Written submissions from City and Gateway Urban Design Framework Stage 2 Community engagement

14.4 Structure Plan North Watson

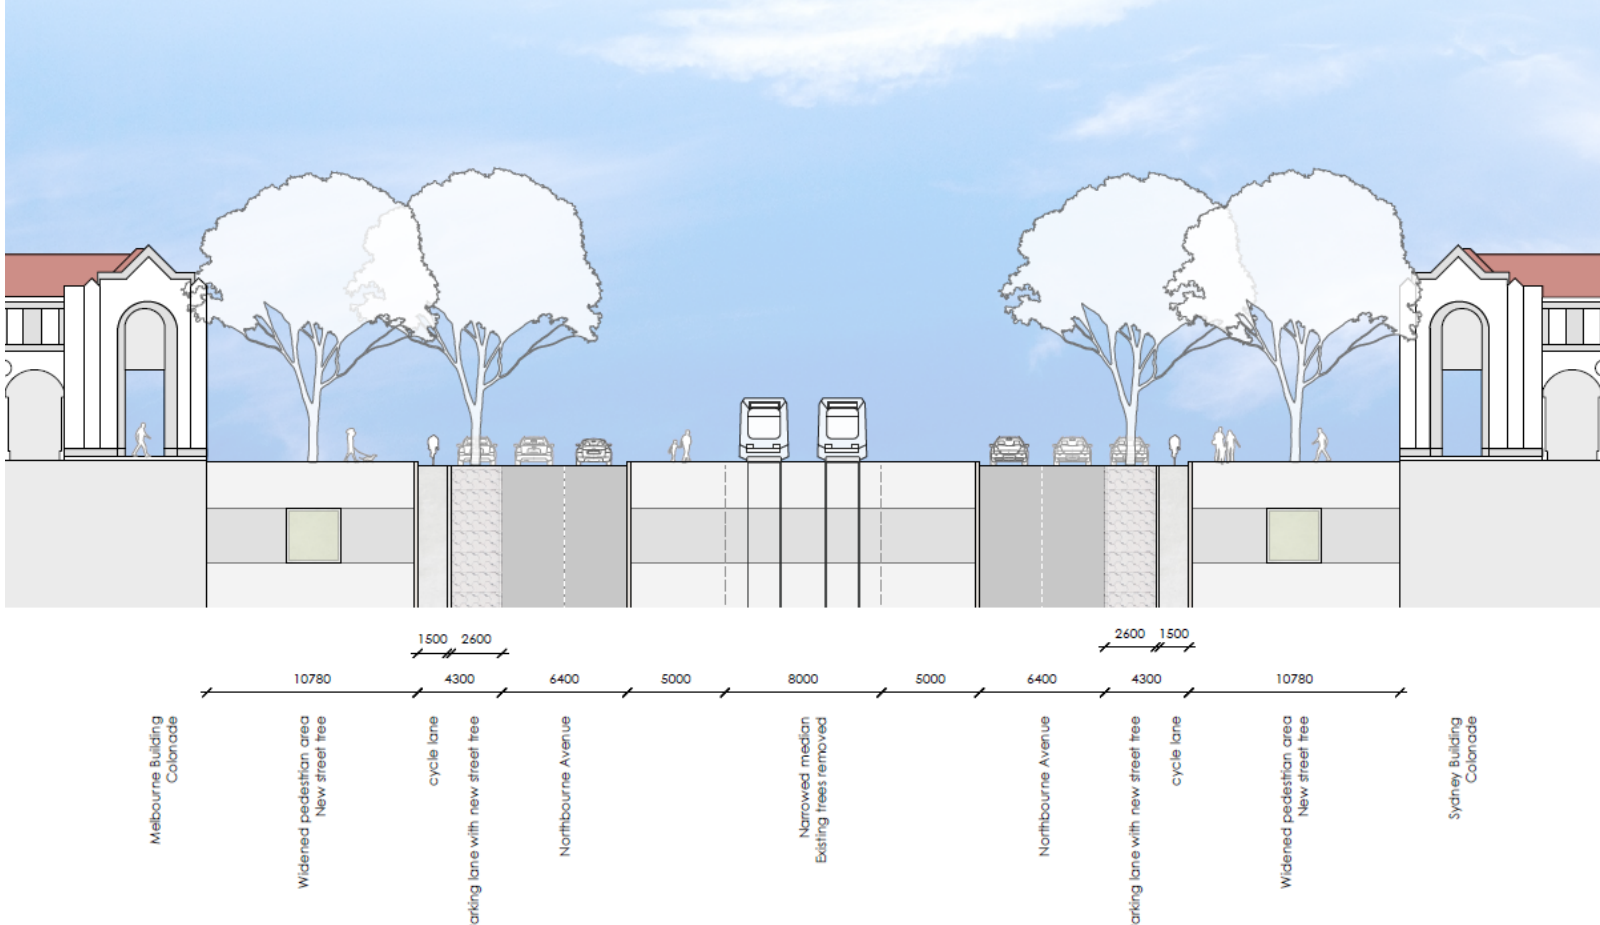
No.	Submission
	<p>DISCUSSION ON THE STRUCTURE PLAN FOR NORTH WATSON</p> <p>It is important to discuss the North Watson structure plan (2008) in context with the 2018 Draft Framework. There are four blocks of ACT government-classified Future Urban Area (FUA) land fronting Northbourne Avenue. By a process of reduction it has come to our attention that there are 935 dwelling left to be constructed on all of the FUA areas remaining in north Watson. This includes one block which is leased by owners of the Catotel tourist complex on Antill Street. At most this would allow an average limit of 45 dwellings per hectare of available land. It will be interesting to foresee if any of the building on ACT government unleased land will be developed to four to six storeys in height in future developments. I agree with a reduced 8.5 metre height limit for buildings fronting Northbourne Avenue in Watson.</p>

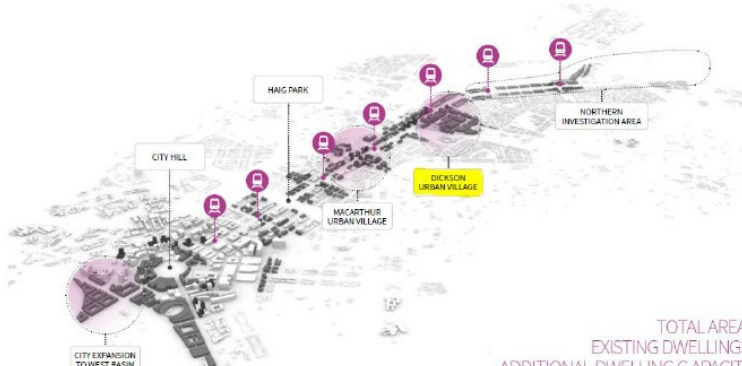
No.	Submission
	<ul style="list-style-type: none"> Development to Increase Connections to Public Transportation The site for the proposed development area is predicted for high population growth due to its convenient location to the transport corridors of Northbourne Avenue and east-west active travel connections, bus stops, light rail station and proximity to the Dickson Group Centre. Nodes of increased residential density are required to support population growth which will in turn decrease demands on private transportation with the support of public transit. Map 2 – spatial framework of the Draft Framework showing the proposed long term structure of the corridor <div data-bbox="369 451 862 1409"> </div> <div data-bbox="907 451 1691 821"> </div> <div data-bbox="907 858 1332 882"> <p>MAP 11 DICKSON URBAN VILLAGE FRAMEWORK PLAN</p> </div> <div data-bbox="907 901 1668 1345"> </div> <div data-bbox="1713 858 2094 1345"> </div> <p>Map 11 of the Draft Framework shows the Dickson urban village framework plan</p>
